Project	IEEE 802.16 Broadband Wireless Access Working Group < http://ieee802.org/16 >	
Title	Inheritance Relationship of 802.16 Mobility MIB	
Date Submitted	2006-03-06	
Source(s)	Yanbiao Chen	xu.ling@zte.com.cn
	Ling Xu	
	ZTE corporation	
	Daning Gong	gongdaning@catr.com.cn
	CATR	
Re:	Contribution to IEEE 802.16i	
Abstract	In this contribution, we propose to provide inheritance relationship of 802.16 mobility MIB	
Purpose	Adoption	
Notice	This document has been prepared to assist IEEE 802.16. It is offered as a basis for discussion and is not binding on the contributing individual(s) or organization(s). The material in this document is subject to change in form and content after further study. The contributor(s) reserve(s) the right to add, amend or withdraw material contained herein.	
Release	The contributor grants a free, irrevocable license to the IEEE to incorporate text contained in this contribution, and any modifications thereof, in the creation of an IEEE Standards publication; to copyright in the IEEE's name any IEEE Standards publication even though it may include portions of this contribution; and at the IEEE's sole discretion to permit others to reproduce in whole or in

Figure 13 IEEE802.16 NRM PacketCS Inheritance Diagram

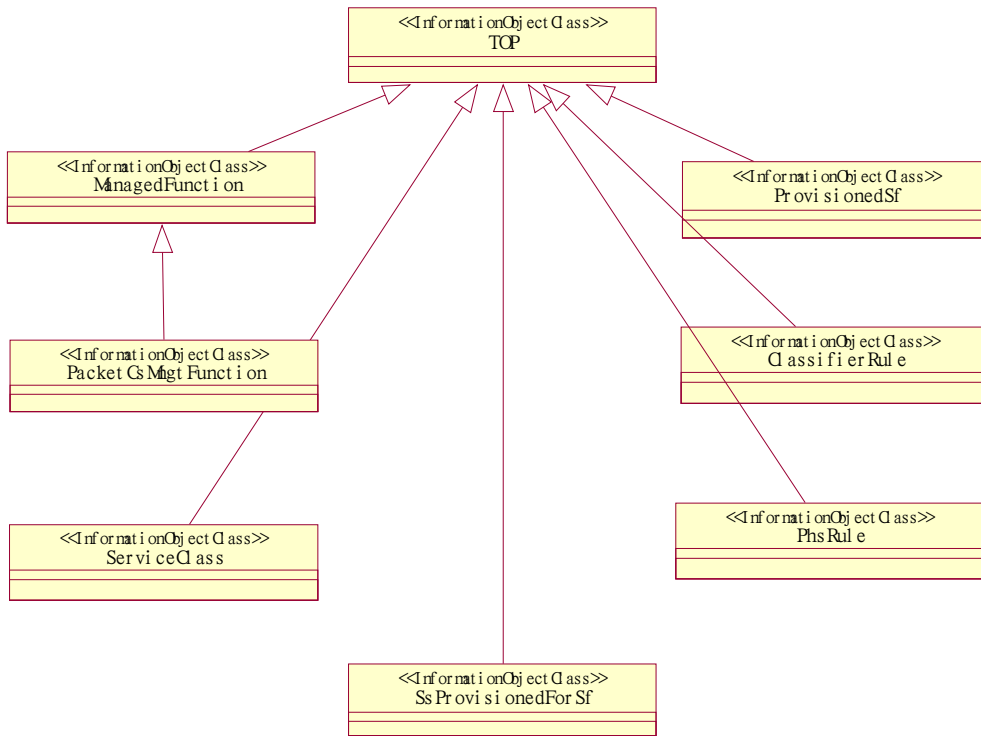
[Add the following description into 16i 15.1.2.2.2:]

The PacketCS IOC inheritance hierarchy:

Figure 14 IEEE802.16 NRM CPS Inheritance Diagram

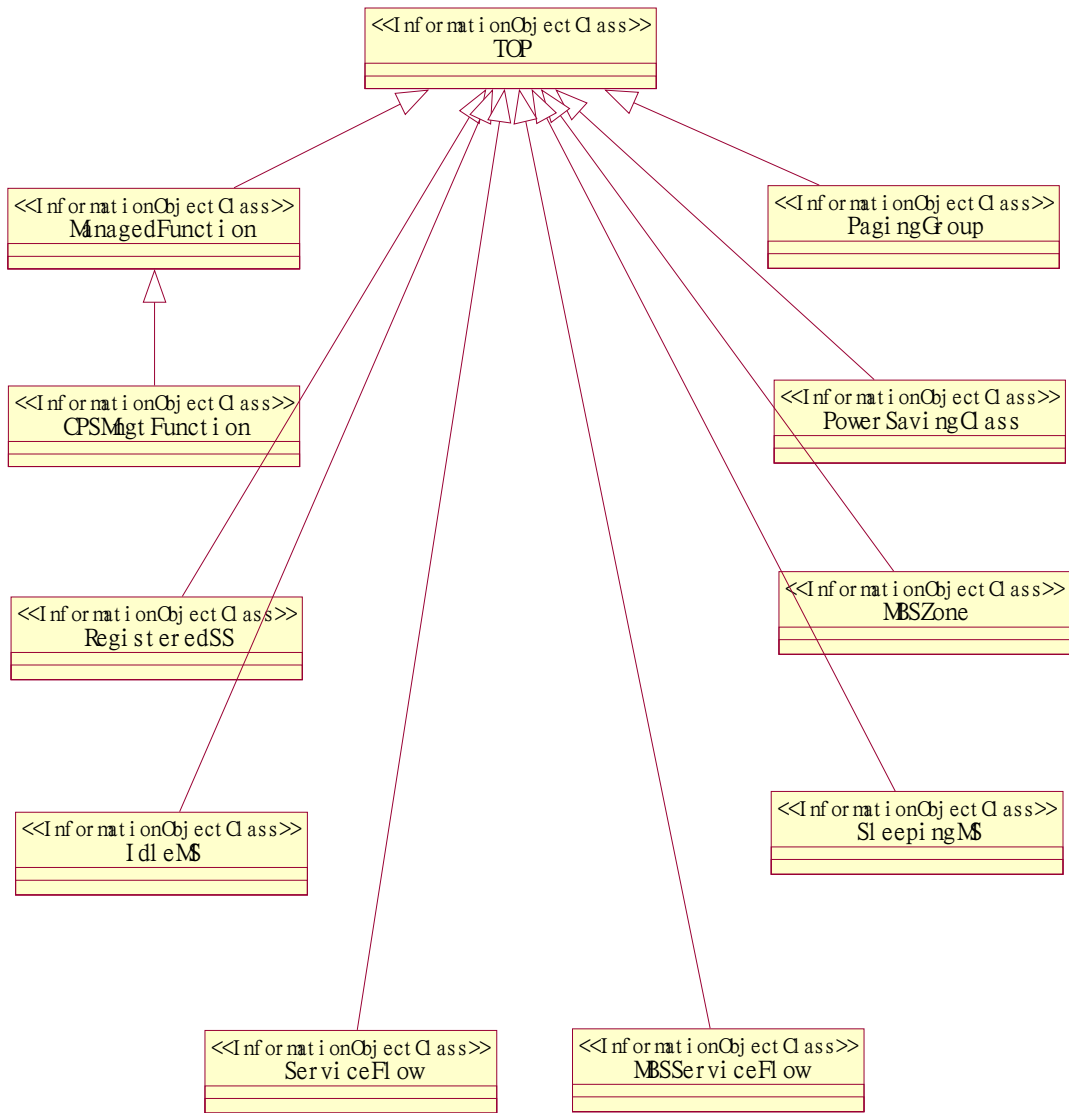
The CPS IOC inheritance hierarchy:

Figure 15 IEEE802.16 NRM Security Sublayer Inheritance Diagram

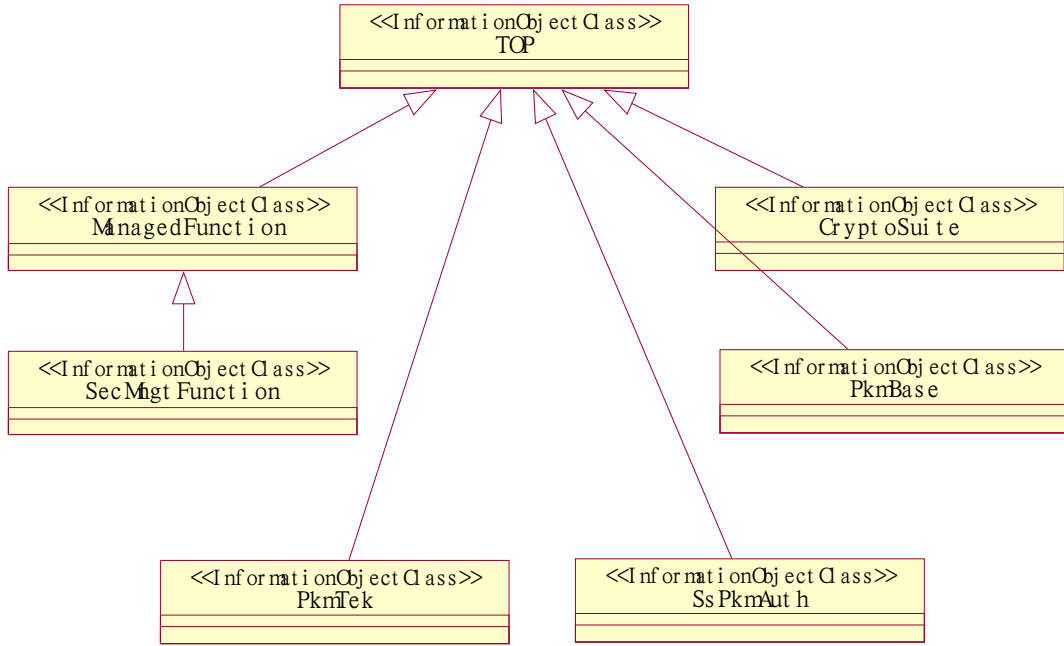
The Security sublayer IOC inheritance hierarchy:

Figure 16 IEEE802.16 NRM PHY Layer Inheritance Diagram

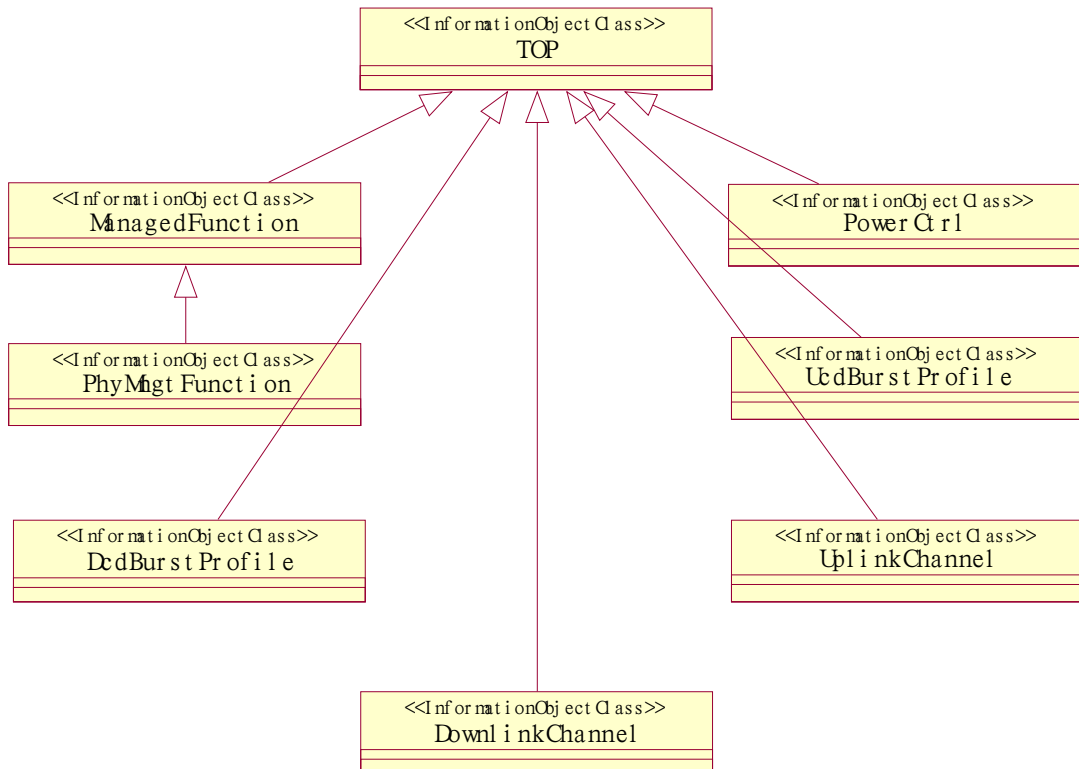
The PHY layer IOC inheritance hierarchy:
